Value Engineering

Final Report

Grand Valley Irrigation Company Fish Screens

February 28, 2000

Figure 11. Overview Plan Proposal No. 6.

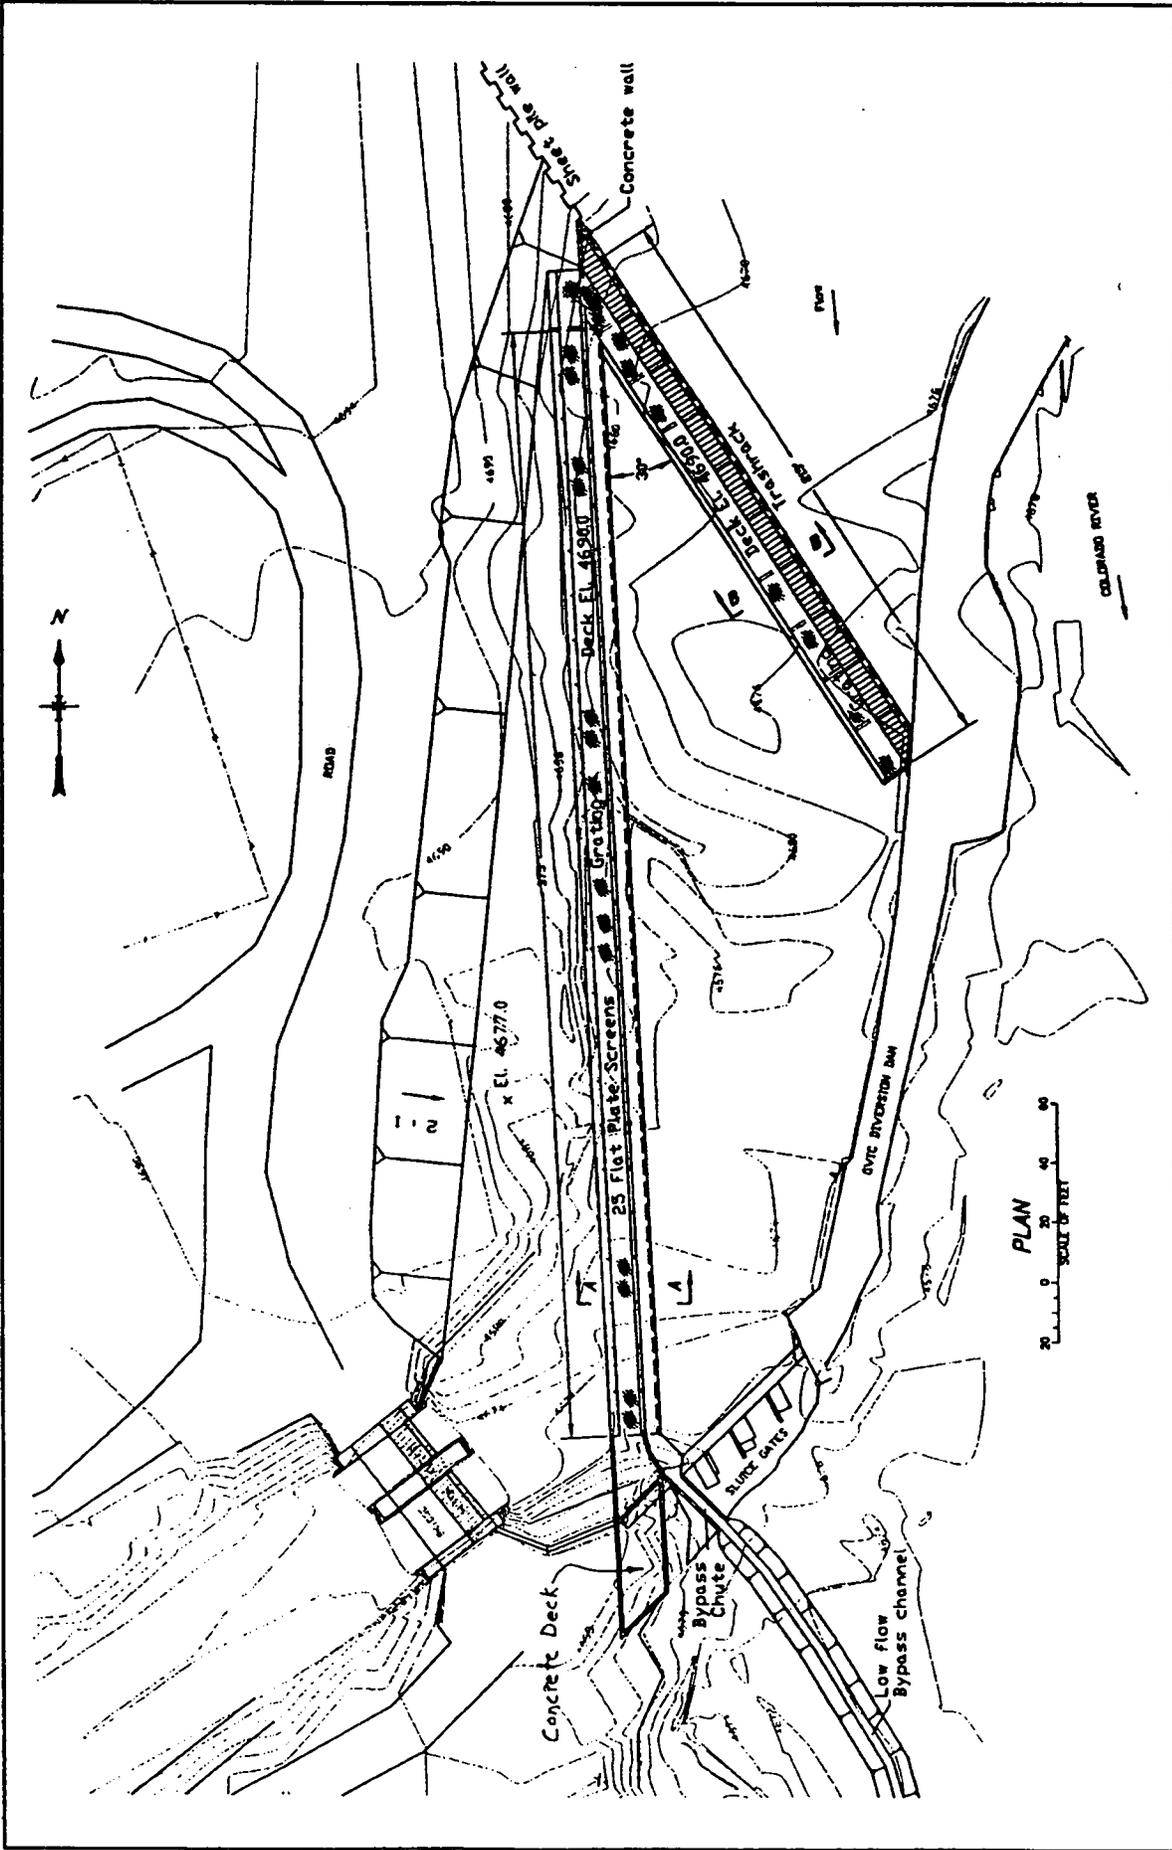
- **Proposal Description:** Option E would place all components in the river upstream (outside) of the Grand Valley Irrigation Company facilities, as shown in Figure 11.
- **Critical Items to Consider:** Location, depth, maintainability and unknown factors.
- **Ways to Implement:** Study in more detail and redesign to: include refinements to enclose the gap between the deck and the flood gates, improve trash deflection, and clarify access. May require baffling. Requires multiple squeegees to clean.
- **Changes from the Baseline Concept:**
 - . River volume and flows considerably higher than would be experienced in the canal.
 - . Significantly larger, more complex and more expensive facility.

Figure 12. Overview Plan Proposal No. 7.

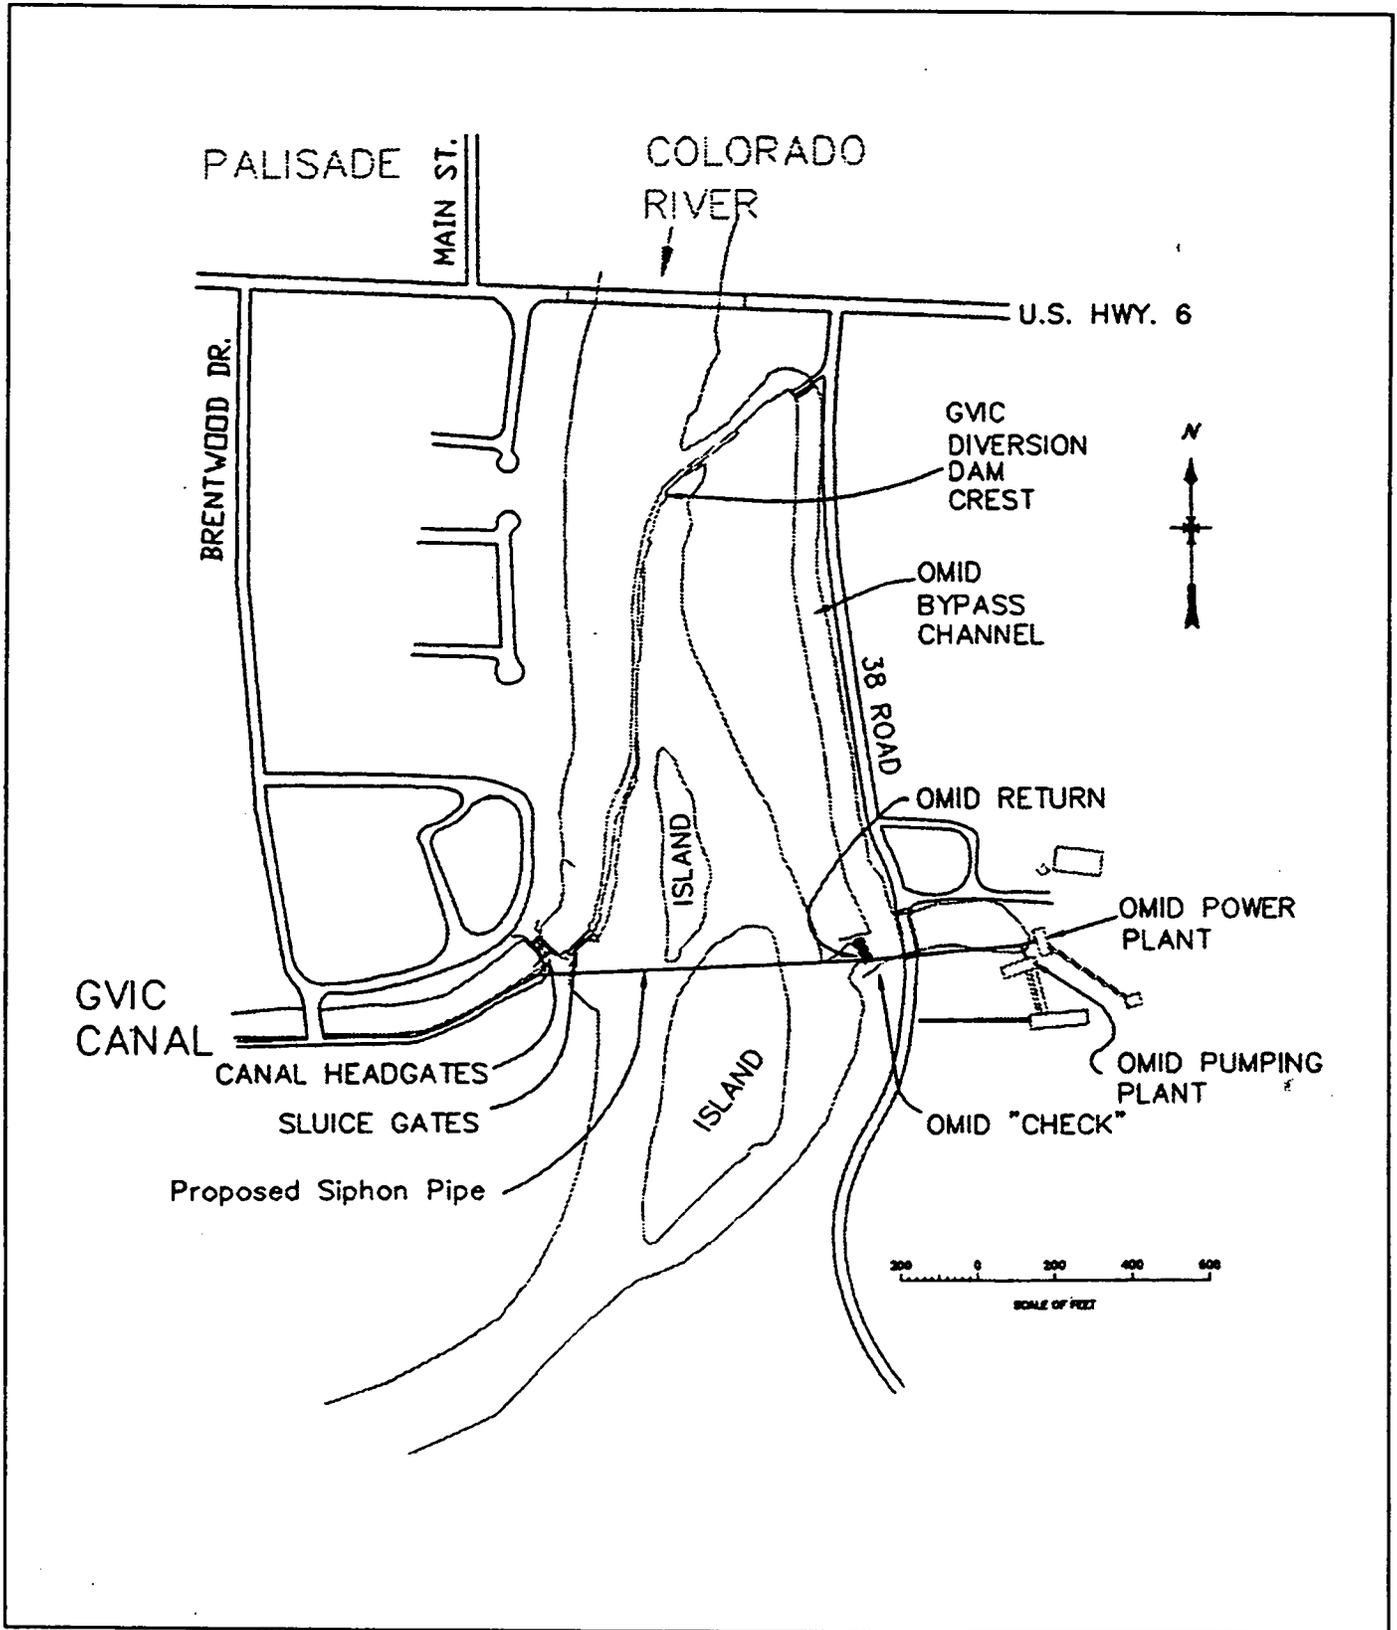
The OMID power canal, powerplant and hydraulic turbine pumping plant are across the river east of the GVIC headworks. The OMID power canal and powerplant each have a capacity of approximately 777 cfs. Typically OMID runs 310 cfs through the powerplant during the irrigation season. The remainder of the flow, 443 cfs, runs through the hydraulic turbine pumping plant to lift 171 cfs to the Orchard Mesa conveyance system. It is assumed that 582 cfs (310 cfs plus 272 cfs) is available to siphon across the river to the GVIC canal from the tailwater areas. (See Figure 13). At low river flows, OMID has a check structure which forces the water to back upstream to a point above the upper portion of the GVIC diversion dam. It is assumed that the resulting tailwater surface elevation during this checking has a slight impact to the efficiency (decrease in head) of the powerplant and pumping plant, but this is still in an acceptable operation range.

- **Critical Items to Consider:**
 - . Impacts to existing agreements between OMID and U.S. Fish and Wildlife Service.
 - . Reduced efficiencies on power and pumping plants from continuous high tailwater.
 - . Is this a change in the point of diversion for GVIC and impact to existing water rights?
 - . Administration of water rights by State Water Engineer.
 - . Consider how to divert flow when OMID is not operating.
 - . Rotating belt screen on the headworks to supply the remaining 80 to 100 CFS.
 - . Consider increasing the intake into the Highline Canal to produce the total flow (660 CFS) required by GVIC.

- Ways to Implement:
 - . Construct inlet structures at the discharge points of the power and pumping plants.
 - . Construct a siphon across the river.
 - . Construct a siphon outlet in the canal.
 - . Install two small traveling belt screens on existing canal headworks.
- Changes from the Baseline Concept:
 - . Substantially reduces quantity of flow to be screened and eliminates proposed trashrack.

Figure 14. Overview Plan Proposal No. 8.

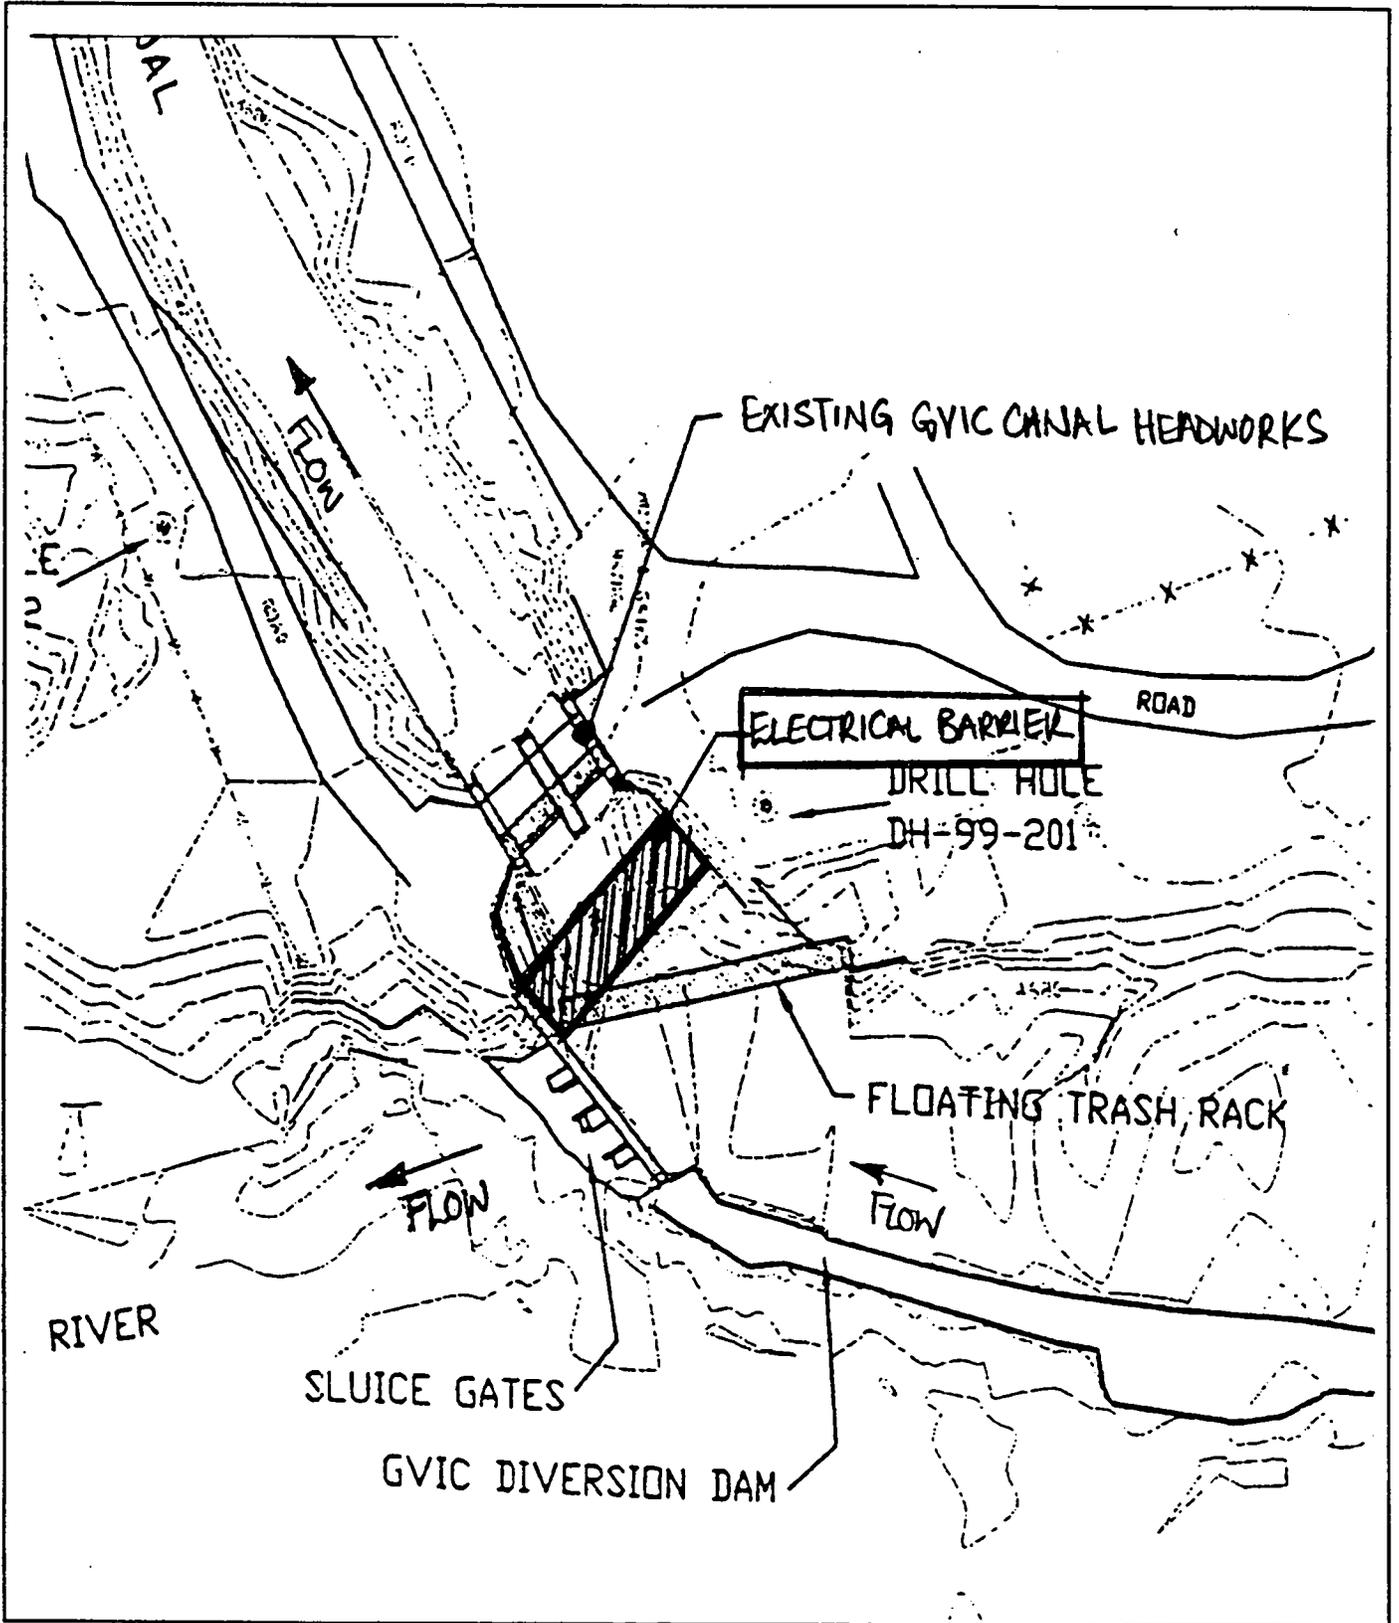
- **Proposal Description:** An electrical barrier would be used instead of a positive barrier fish screen structure to exclude fish from GVIC diversion flows at the existing GVIC Diversion Dam Canal Headworks. The barrier would be located in-river and upstream of the existing head gates (Figure 14). The barrier would be designed and constructed to minimize or eliminate the entrainment of adult and juvenile target species (Colorado Pikeminnow and Razorback Sucker). The barrier can be oriented at an angle with respect to the existing headworks structure to create a barrier that fish could sense and avoid. Adequate sweeping flow for guidance past the barrier could be provided using the existing diversion dam floodgates during times when sufficient river flow is available. However, low flow periods would likely represent a limiting case when the electrical barrier performance is less than optimal. During these periods the barrier could be shut down or remain operating. Debris and trash would be handled in the same manner as with the existing facility (i.e., no additional debris removal facilities are required).

- Could represent a public safety hazard.
- Target species behavior may not be conducive to application of electrical barriers (i.e., ineffective for exclusion, causes injury to fish, etc.)
- Long term O&M is a question.
